Re: GMD-2018-41

Thanks so much for sending us two referees' comments and suggestions on our manuscript "Carbon-nitrogen coupling under three schemes of model representation: Traceability analysis" (GMD-2018-41). We greatly appreciate the two reviewers for their valuable comments and suggested amendments. Their inputs have helped improve the paper tremendously. We have carefully studied the comments from the reviews and made revisions based on them in this version of manuscript.

## Response letter to comments (gmd-2018-41)

Figure R1. Comparisons of GPP, NPP, ecosystem C storage and ecosystem N storage at the steady state from this study vs. the TECO-CN version used previous work.

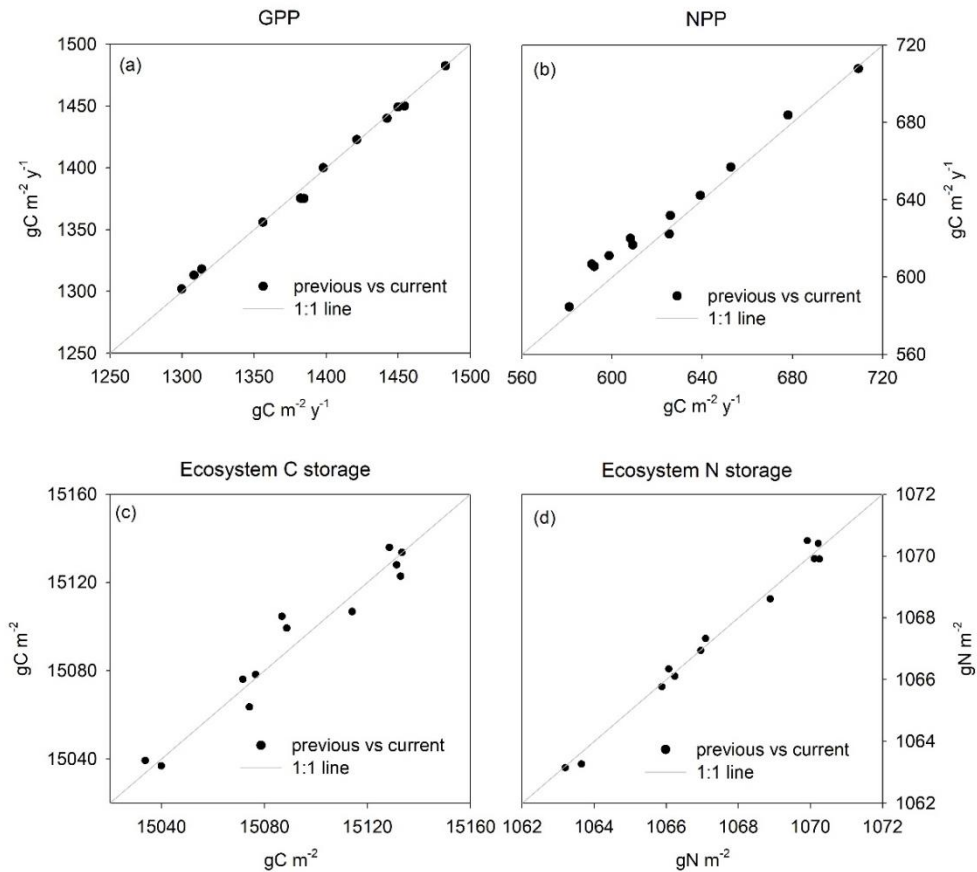
*In previous work this author group has demonstrated that the matrix approach gives identical results to the conventional system of differential equations. Can a similar plot be made with a CN version of TECO? That is, can lumping a coupled C:N model into a "N scalar" (eq. 33) account for everything that's going on in the model? I'm assuming it can, but this is never clearly demonstrated in the results.*

**[Response]** That version of TECO-CN had incorporated the "N scalar" into the respiration and decomposition rate modifier (Du et al. 2017), which had been used in the previous work (e.g., Zaehle et al., 2014). In this study, N scalar is a key factor, and we separated it from the environmental scalar ( $\xi_E$ ) and baseline carbon residence time ( $\tau'_E$ ) in the traceability analysis framework to trace the different effects that were introduced by the three C-N schemes. We also compared our TECO-CN version with the version used in Zaehle et al., 2014. We found that the results matched well (See Figure R1 below).

**Figure 5.** The annual average sizes of carbon pools (panel a) at the steady-state among 1996-2007 for C-only version and the three C-N schemes (SM1, SM2 and SM3) and the C:N ratio (panel b) of each carbon pools for the three C-N schemes (SM1, SM2 and SM3) in TECO-CN model.

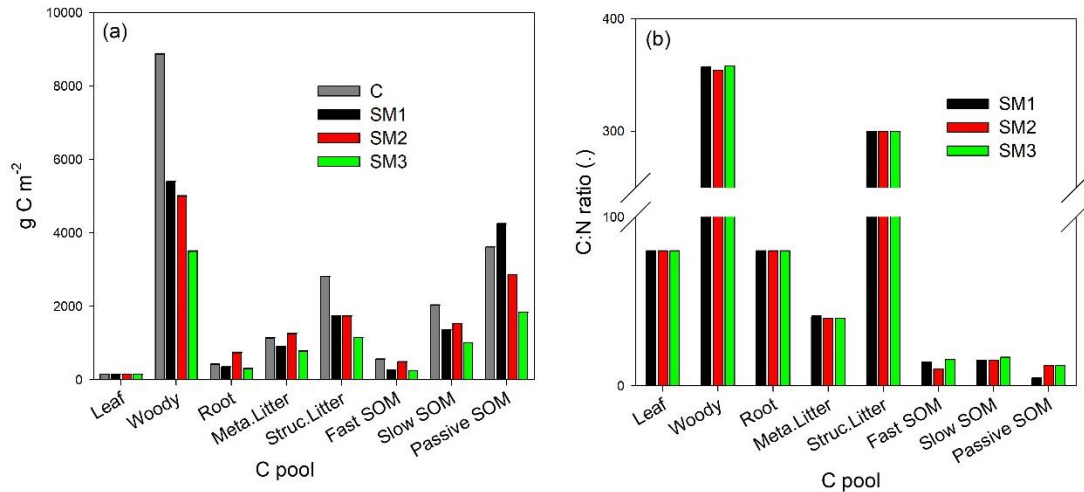
*Line 473: This line really makes me wonder if the approach outlined here is 'right'? Regardless, it makes me think that differences among models are 100% attributable to differences in stoichiometric assumptions among models. If so, should a list of pools and their C:N ratio SM1, 2, and 3 be communicated?*

**[Response]** Thanks for your comments. We added a new figure in the revised version (Figure 5). Please see below for details.
